**RESPONSES OF WINDHAM SOLAR, LLC
TO
CONNECTICUT SITING COUNCIL INTERROGATORIES - SET ONE**

On August 10th, 2020, the Connecticut Siting Council (“Council”) issued Interrogatories, Set One to Windham Solar, (“Petitioner”), relating to Petition No. 1359A. The Petitioner offers the following responses.

| <p>BENZ STREET SOLAR</p> <p>GRADING AND EROSION CONTROL PLAN</p> | | | |

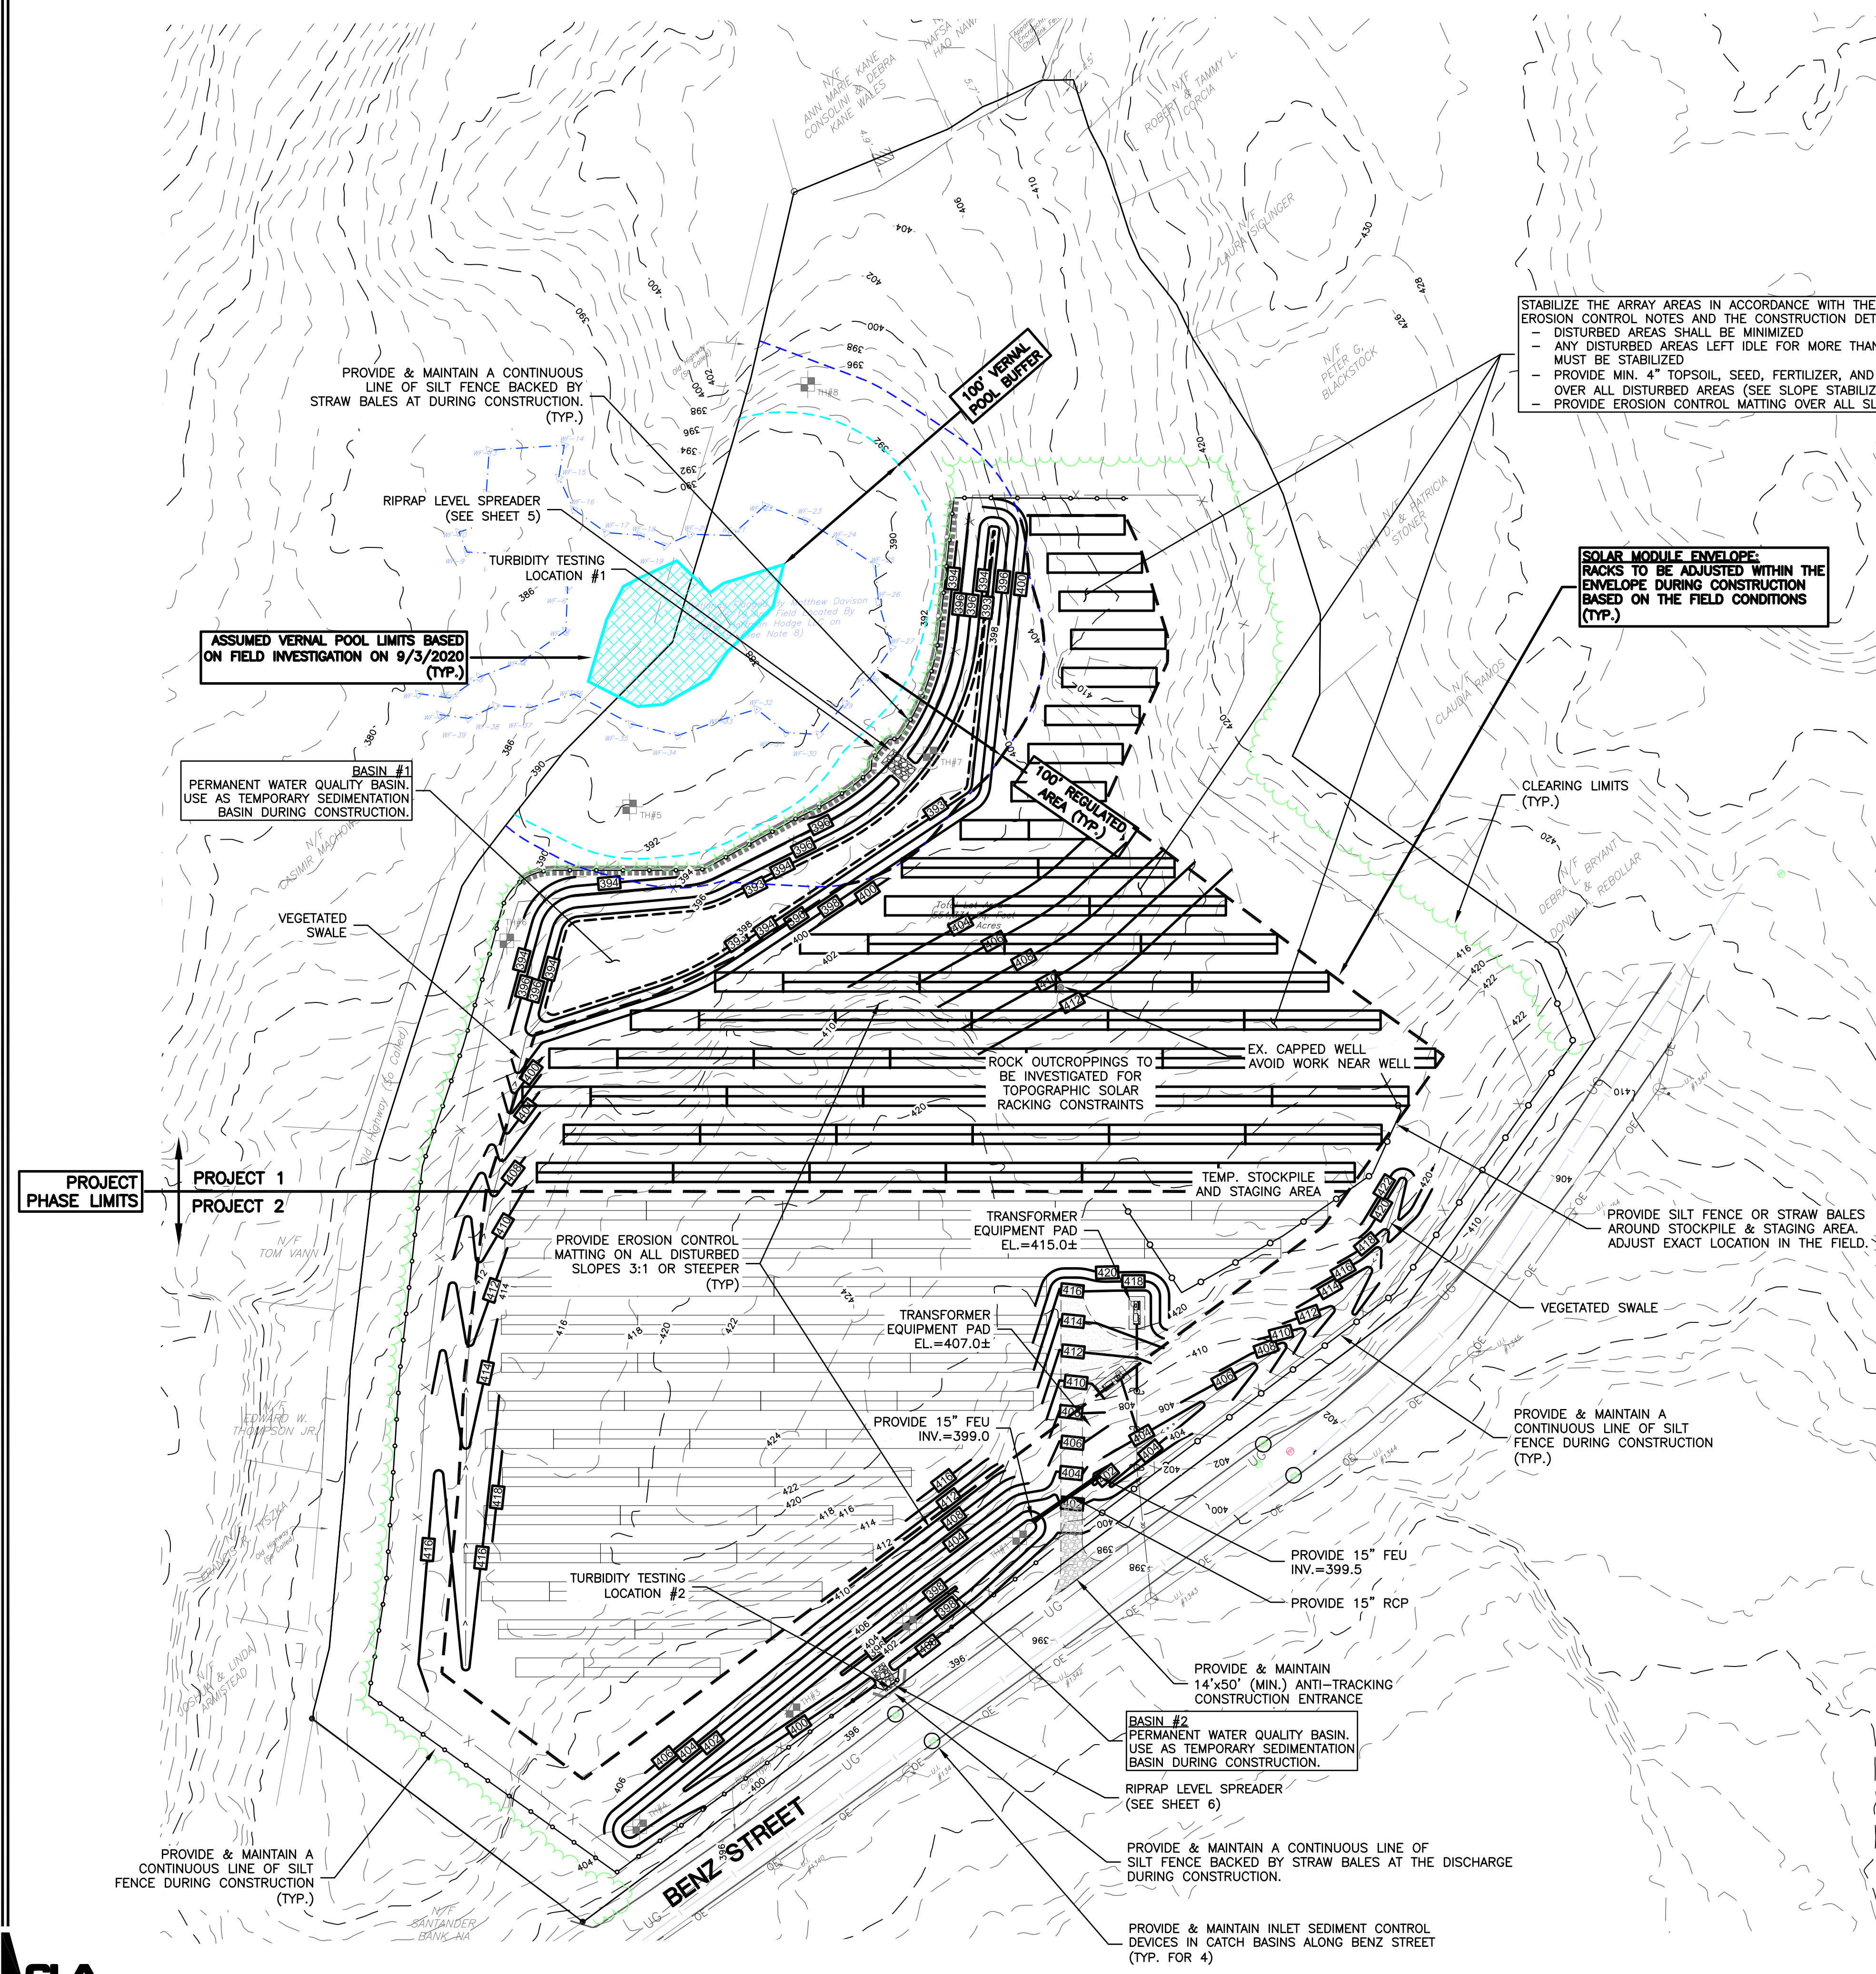
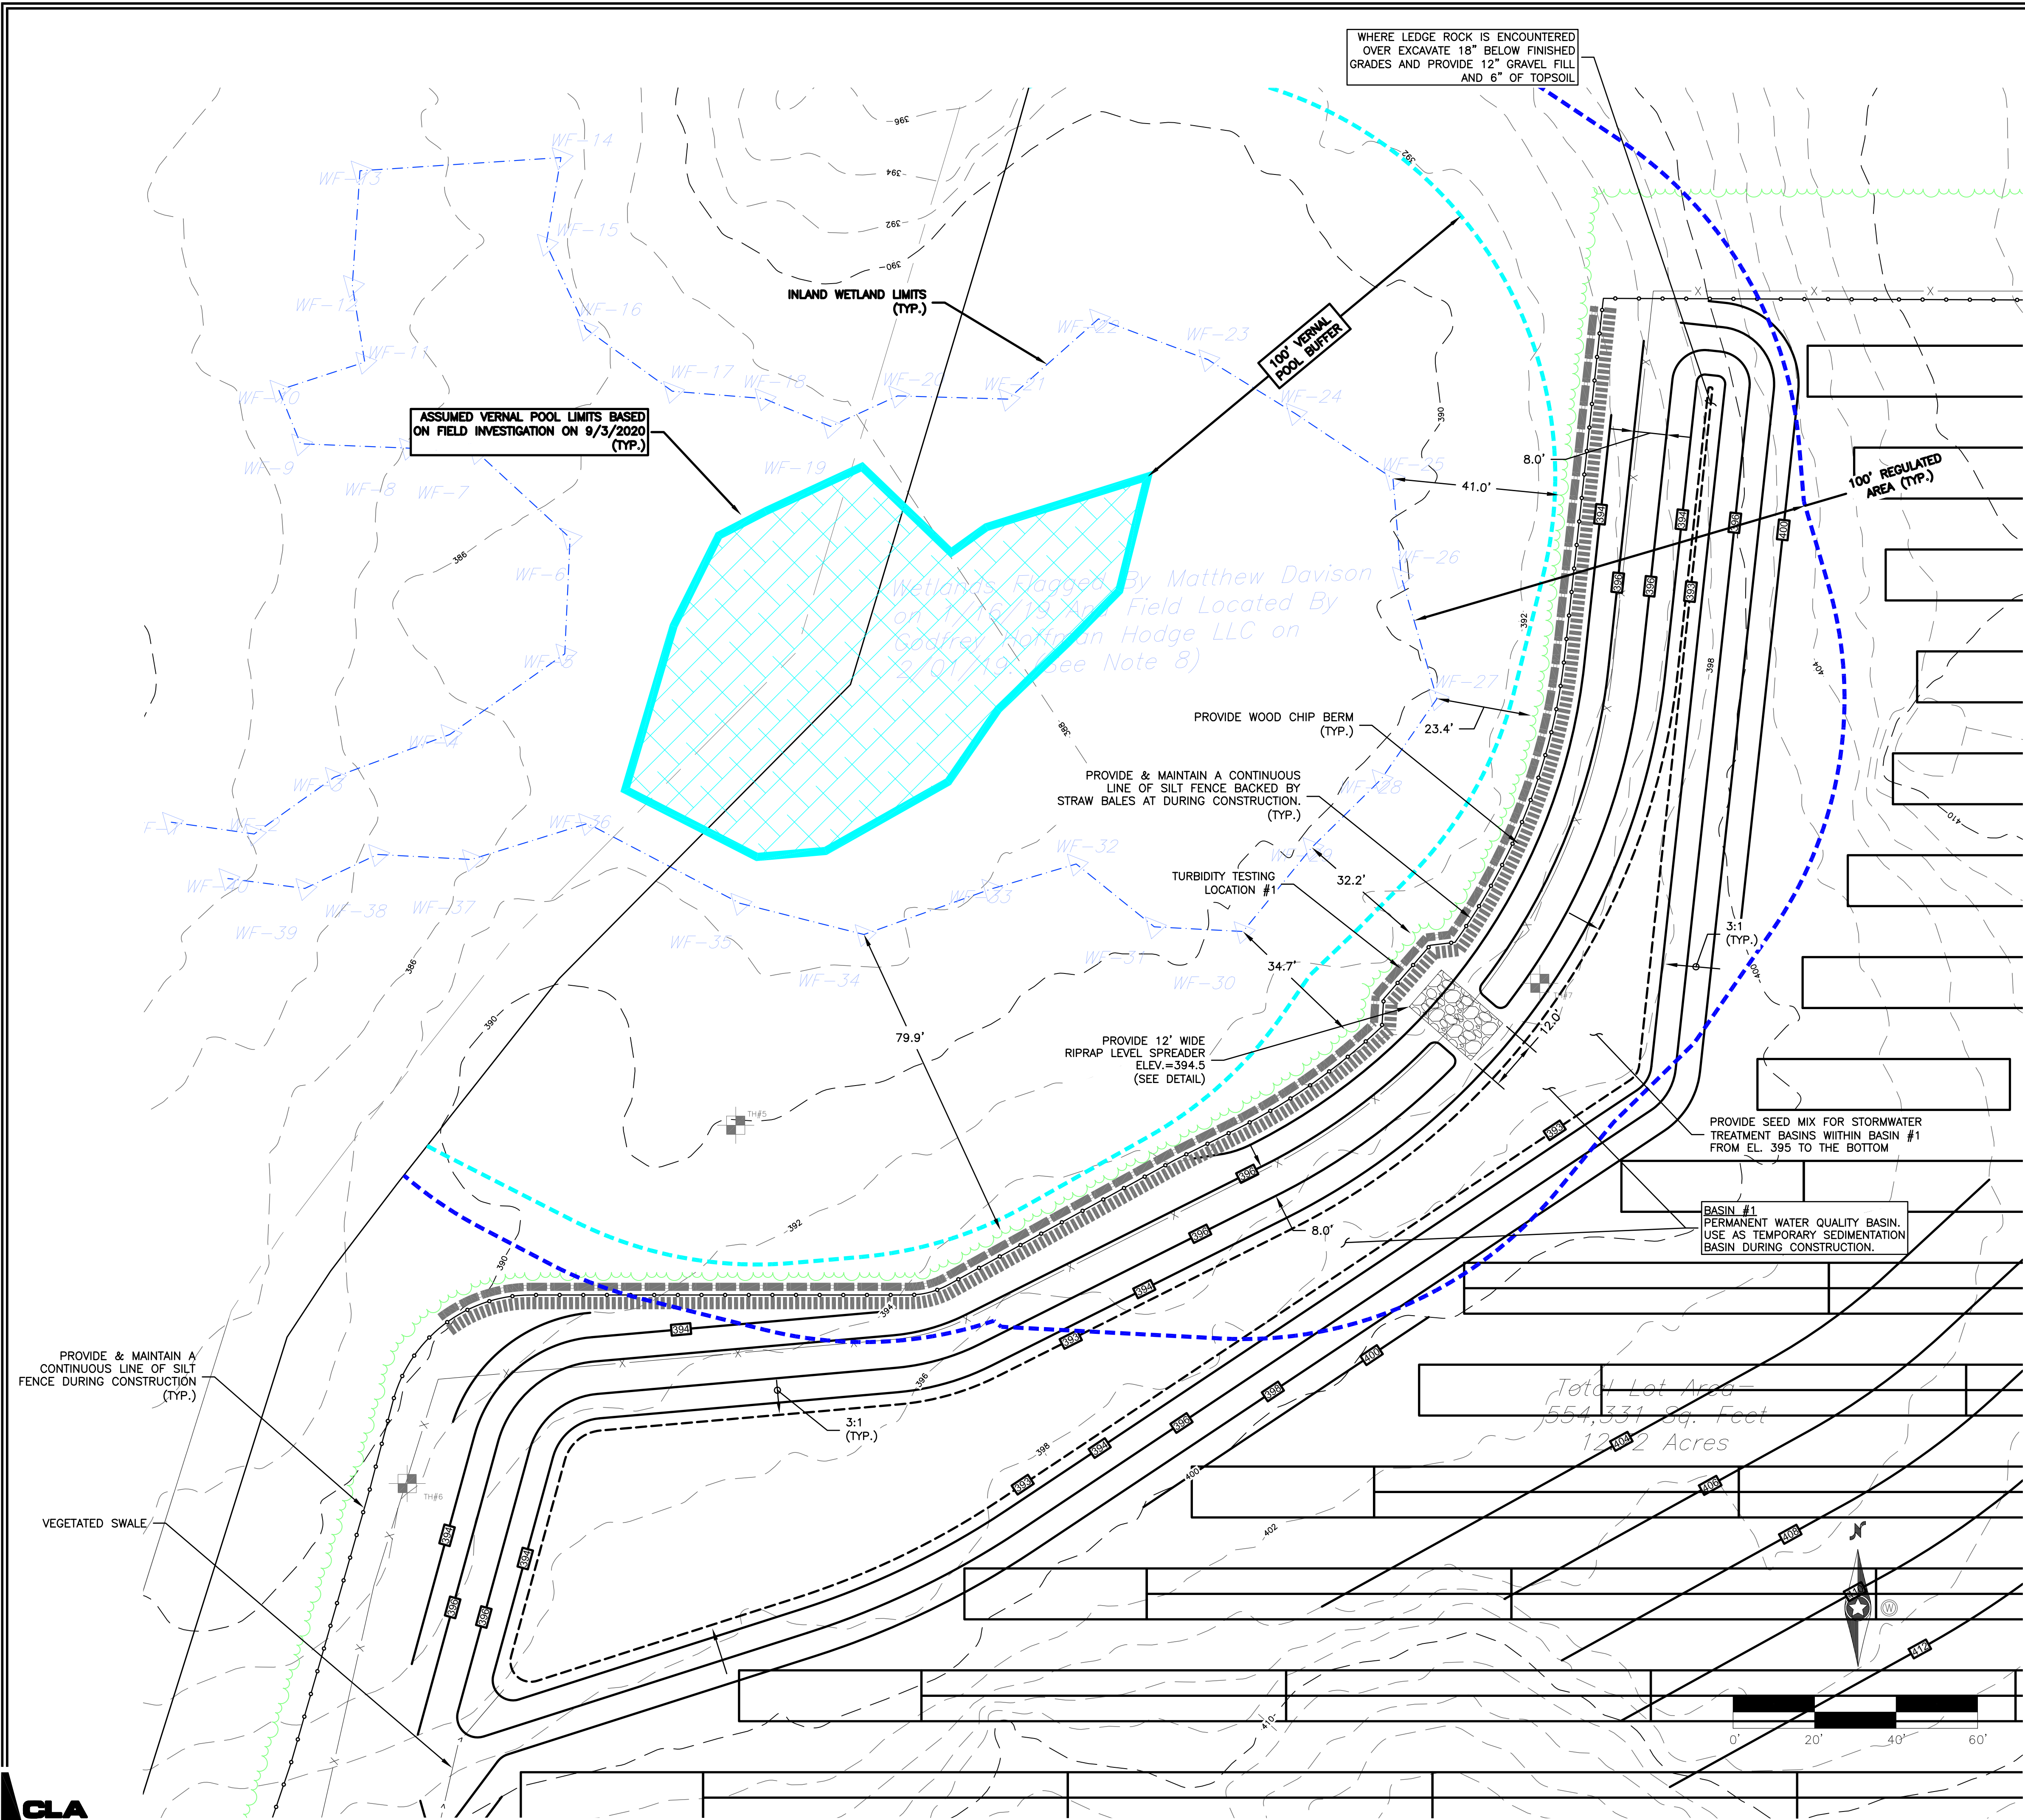
26. Referring to Site Plan Sheet 4, a callout box notes *rock outcroppings to be investigated for solar racking constraints*. What issues are in these areas?

The rock outcroppings create a quick transition in grade, where the continuous racking may have to be broken by several gaps or sections of racking removed all together area. The Petitioner would like the siting council to consider the envelope of the array as the limits of solar panel construction, not the individual tables as represented in the site plan. Each solar racking manufacturer has grade and topographic constraints. Specific electrical and racking design elements will further be investigated at that time of final electrical design and submission of a development and management plan.
